Mask Set Errata for Mask 2M44C

This mask set errata applies to the mask 2M44C for these products:

- MC9RS08KA2
- MC9RS08KA1

Figure 1. Observed Slow and Nonlinear V_{DD} Ramp

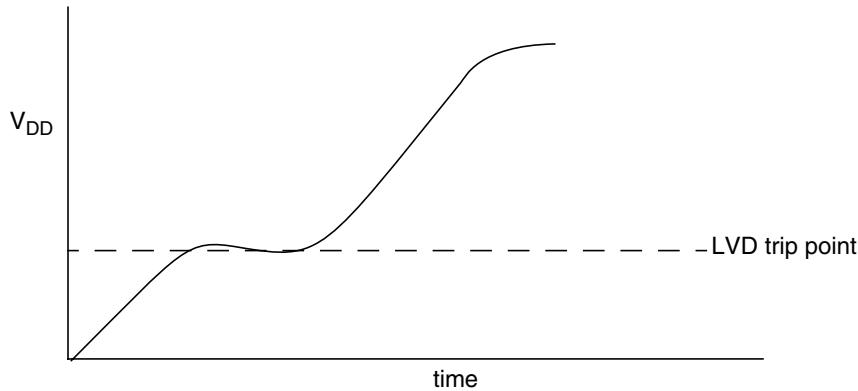
Case 1 If there is a pullup on PTA0 when V_{DD} of the MC9RS08KA2 is driven with a very slow and nonlinear power-up sequence, the part can enter a non-functional static condition where the MCU is not executing code.

An example waveform is shown in [Figure 1](#).

There are two suggested workarounds. The first is to ensure that PTA0 is low until the voltage on V_{DD} is above a level of 2.4 V. This can be accomplished with a pulldown on the pin or a small capacitor to slow the rise of the PTA0 pin during power up.

A faster rise time on V_{DD} , faster than 2 V/ms, can prevent both of the issues.

Figure 2. Observed V_{DD} Ramp Conditions that Cause Inconsistent Startup

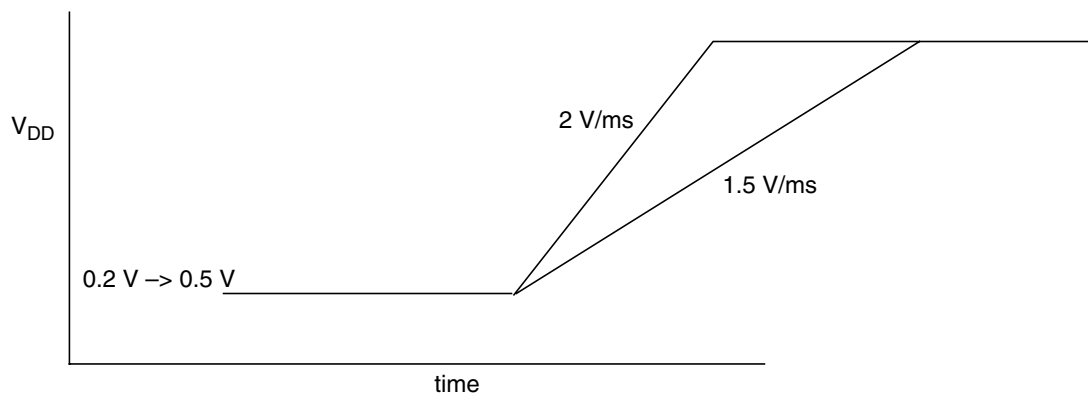
Case 2 It has been observed that when V_{DD} of the MCU is driven with a voltage ramp of 1.5 V/ms to 2.0 V/ms from a residual voltage on V_{DD} between 0.2 to 0.5 V, the MCU begins to execute code and enters one of two states.

- a) If LVD is enabled (default), the part will repeatedly start to run code followed by a reset from the LVD.
- b) If LVD is disabled by the user code, the code will run only for a short time and then stall.

The second workaround is to not allow a residual voltage between 0.2 to 0.5 V on V_{DD} followed by a ramp of V_{DD} from 1.5 V/ms to 2 V/ms. The addition of a discharge resistor in parallel with the bypass capacitors will allow the V_{DD} to be discharged. The specific component values to use depend upon the circuit's operation during V_{DD} ramp conditions.
